U.S. NUCLEAR REGULATORY COMMISSION
SAFETY EVALUATION REPORT BY THE OFFICE OF NEW REACTORS
TOPICAL REPORT TR-0915-17564, "SUBCHANNEL ANALYSIS METHODOLOGY,"
REVISION 2, NUSCALE POWER, LLC
DOCKET NO. 52-048

Figure 2. Comparison of nucleate boiling heat transfer correlations

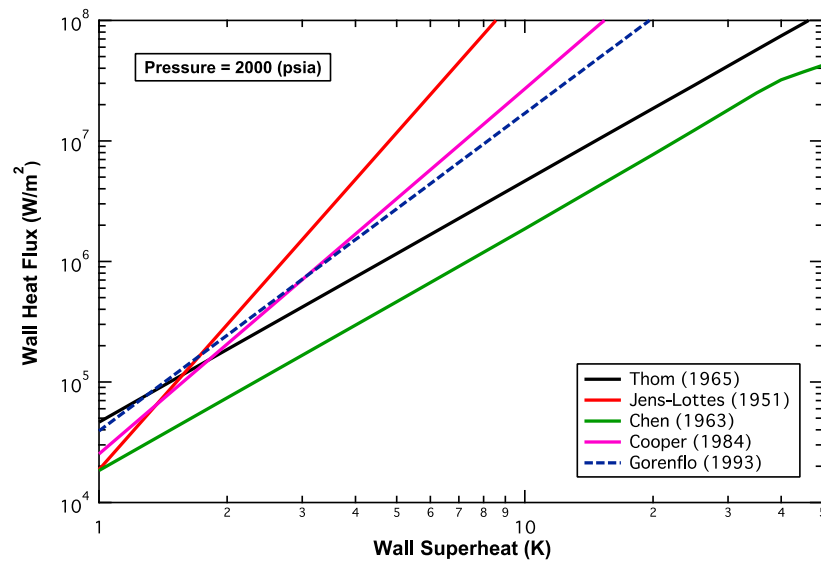
In modern boiling heat transfer models, the forced convection and nucleate boiling components are added in a similar fashion to that used in the THSP correlation option. The NRC staff concludes that the THSP correlation option provides a conservative result because of three factors:

1. The forced convection component is calculated using the Dittus-Boelter heat transfer correlation. The Dittus-Boelter correlation was developed for heat transfer in tubes and has a consistent bias of a 20- to 30-percent underprediction compared to rod bundle data.
2. The forced convection component of the THSP correlation is calculated for single-phase convection only. Because there is no two-phase multiplier, the forced convection

component would be underpredicted by about a factor of about 2 for a void fraction of 50 percent.

3. When compared to modern nucleate boiling correlations for high-pressure conditions, the THSP correlation is quite conservative, as shown in Figure 2. For example, at 13.79 MPa (2,000 psia) and a wall superheat of 10 degrees C (18 °F), the THSP correlation gives a wall heat flux about one-quarter that of the Gorenflo model that is used in the TRACE code.
